Historic Environment Conservation Consultation Response

Application ref: 25/00887/ADV

Erection of 2 no. internally illuminated aluminium signs measuring 1900mm(w) x 1490mm(h) x 90mm(d), on the north and east elevations of the civic centre for a period of 5 years from 24/08/2025 to 25/08/2030

Site Address: Heywood Civic Hall, LCpl Stephen Shaw MC Way, Heywood, OL10 1LW

Signage that could be retained by RBC or re-used as part of a display within the building

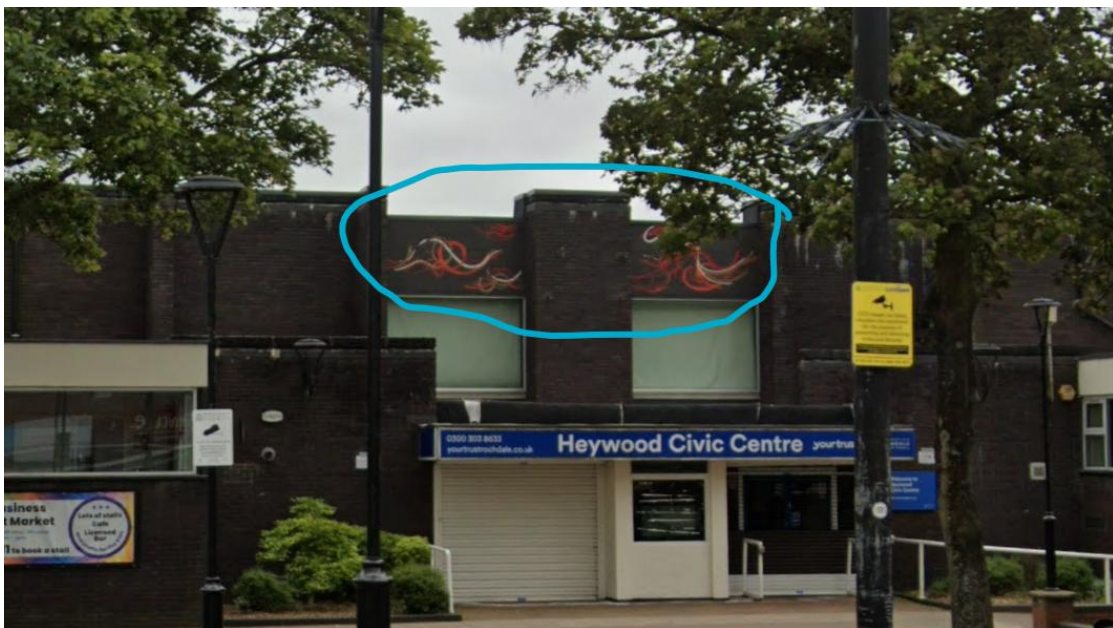
It is somewhat of a shame that various elements of signage telling the history of the building will no longer be seen, notably the late 70s / early 80s typography on the eastern elevation. Please ask the project team to ensure that a full photographic record of the original building and construction process of the building is submitted to the Borough's Local Studies Centre for indexing and future displays. If any physical elements of previous signage were able to be kept by the Council for future posterity, that would be ideal. It could be that parts of the previous external signage could be used internally within the building as a decorative choice alongside a historic interpretation display.

Signage that could be retained by RBC or re-used as part of a display within the building
